# Heavy-duty industry adaptation of gtr22 on in-vehicle battery durability: key issues

EVE IWG - Session 69

April 16th&17th, 2024

# RESULTING FCE FROM ENERGY THROUGHPUT VS. MILEAGE AND YEARS FOR DIFFERENT CASES

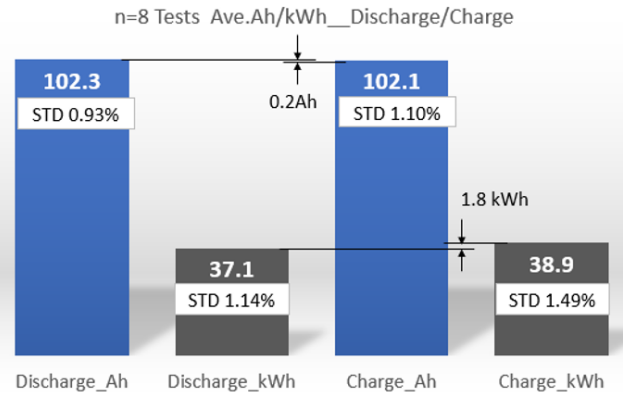
- Different use-cases resulting in different energy throughput, whilst years stay same
- Mileage and FCE do not correlate linearly
- For smaller trucks with small batteries c-rate increases. Thus, smaller trucks with lower installed battery energy cycled more often

## Results(2) Comparison UBE vs. UBC

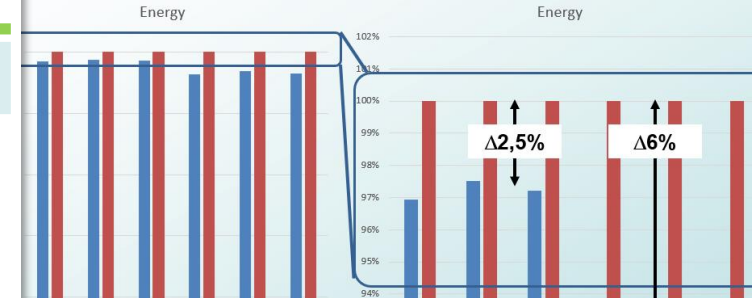
- > UBE(kWh) ; Due to internal resistance, discharge is  $\Delta 1.8$ kWh compared to charging. The variation is 1.14-1.49% which is much larger than UBC due to voltage multiplication.
- > UBC(Ah) ; Measured using DC charging and AC charging, The values are almost same, the difference is  $\Delta 0.2$ Ah. Variation are 0.93 - 1.10 %.

- Capacity is the same in the charging and discharging phase (e.g. Coulomb efficiency approximately 100%)
- Capacity is more reproducibly measurable, since only the current sensor with very high accuracy (e.g. error  $\ll 1\%$ ) is used.
- Capacity can be measured easily and reproducibly as well as technology neutral during the charging process at the charging station. Easy to replicate by third-party organizations or even by customers. Which leads to given transparency and possible validation at all time.

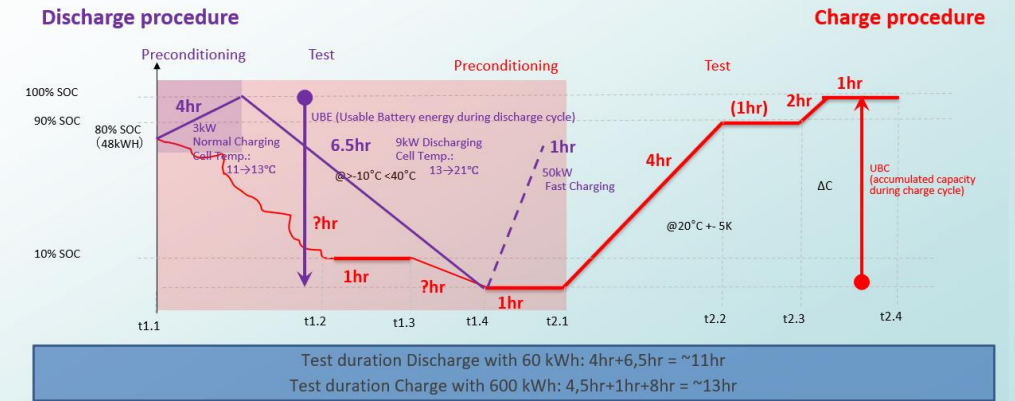
Unlike WLTP which has a defined reference drive cycle, the current proposal for HD to drive on the road with an average speed has a lot of uncertainties during test, eg. driver behaviors, road conditions, brake etc.

Charging process is more static and controllable which eliminates the uncertainties from road test

The customers care charging as much as discharging as operation cost is the key

Report and monitor measurements from charging (following the discharge procedure) as a complement to discharge measurements  
 $\text{SOCE}_{\text{measured}}$  shall be calculated by UBE/UBC from both charge and discharge measurements for the monitor verification.

Results from charging cycle shall be reviewed and compared to results from discharging cycle and to be discussed within phase II of HDV GTR22b whether to this should be reflected within the procedure itself

## COMPARING SINGLE CELL VS. PACK VS. IN-VEHICLE DISCHARGE AND CHARGE RESULTS, EFFICIENCIES ARE ALMOST SAME

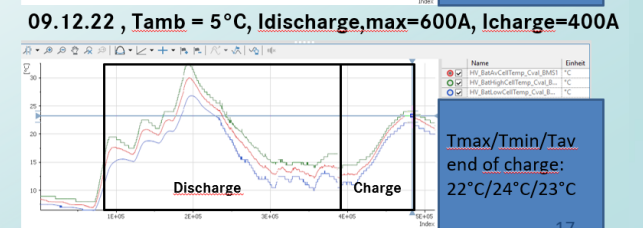
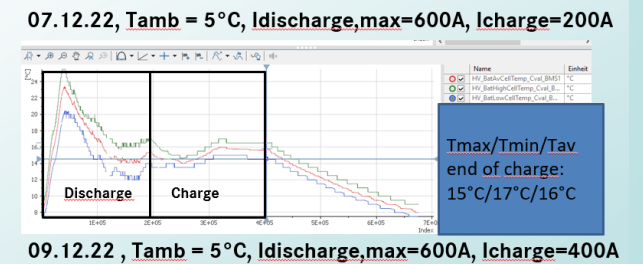
EV 32t Long run In-Vehicle discharge		EV 32t Long run charge	
	07.12.22	09.12.22	07.12.22	09.12.22
C_HV [Ah]	773,12	763,1	776,17	755,49
C_HV_Bat [Ah]	257,71	254,37	258,72	251,83
BMS_SOC_min [%]	4,87	6,62	4,87	6,62
BMS_SOC_max [%]	97,045	97,05	97,01	96,74
E_HV [kWh]	307,21	303,75	320,2	314,84
E_HV_Bat [kWh]	102,40	101,25	106,73	104,95

$$\eta_{\text{Coulomb}} = 99,6\%$$

$$\eta_{\text{Energy}} = 96,0\%$$

## For BiDi vehicles

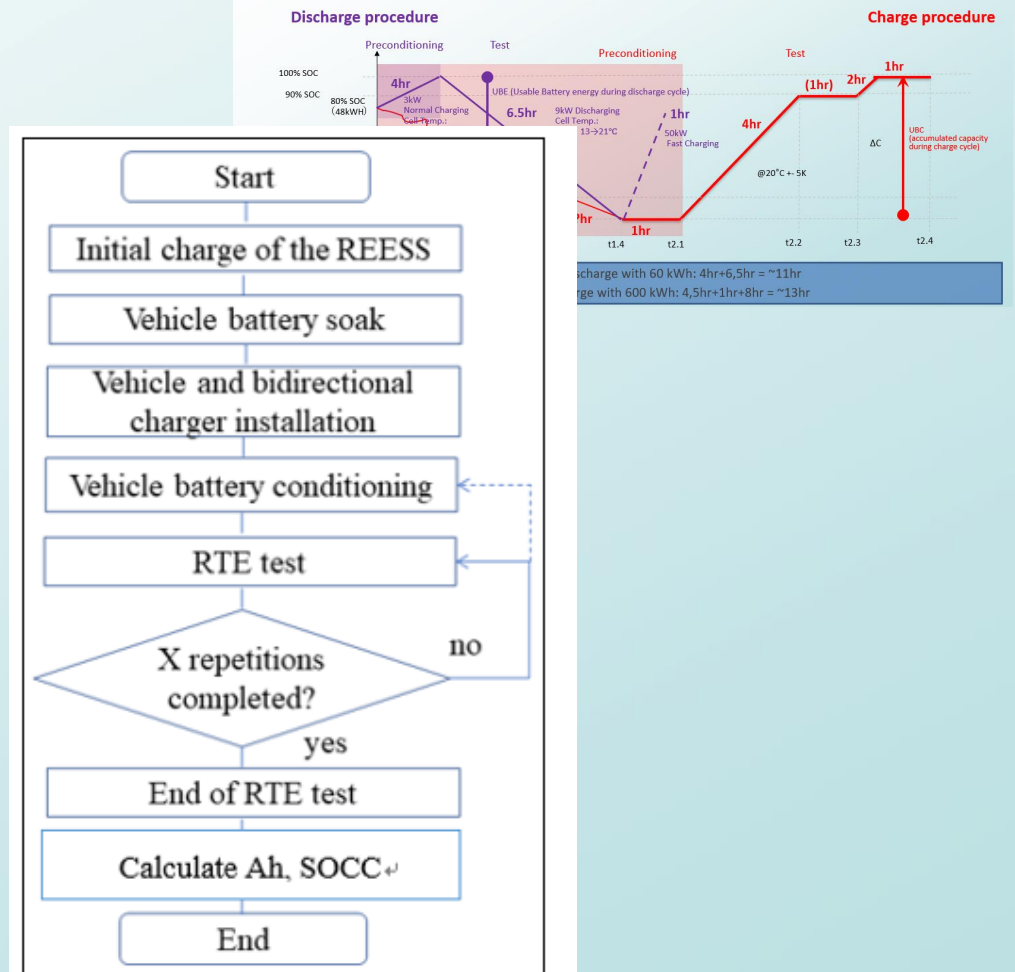
Bidi vehicles also require charging results. Especially during the monitoring phase.

It is necessary to confirm the validity of the Bidi test (again, especially during monitoring phase) due to a lack of experience with it in HDV industry.

Different procedure and by this test flow chart to 1a/b: confirming the accuracy of the test at RTE (Round Trip Efficiency).

## POSITION ON VIRTUAL MILEAGE

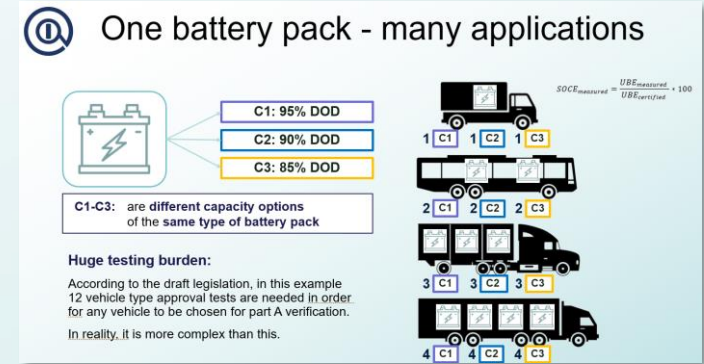
Based on real-world data, we request EVE IWG to rethink the virtual mileage proposal and to consider energy throughput as additional lifetime requirement.

Considering the unique configurations and/or functionalities of HD vehicles:

- 1) Based on expert discussions and real-world data, it is not feasible to differentiate all the separate electric vehicle-internal energy flows
- 2) OICA prefers to apply the whole battery energy/capacity throughput instead of mileage for MPR criteria.

- Virtual mileage and with this Part C odometer needs to be deleted.
- To the customer it adds no value and is not feasible for HDV OEMs to distinguish all the different energy flows from battery to the systems as PTO and so on...
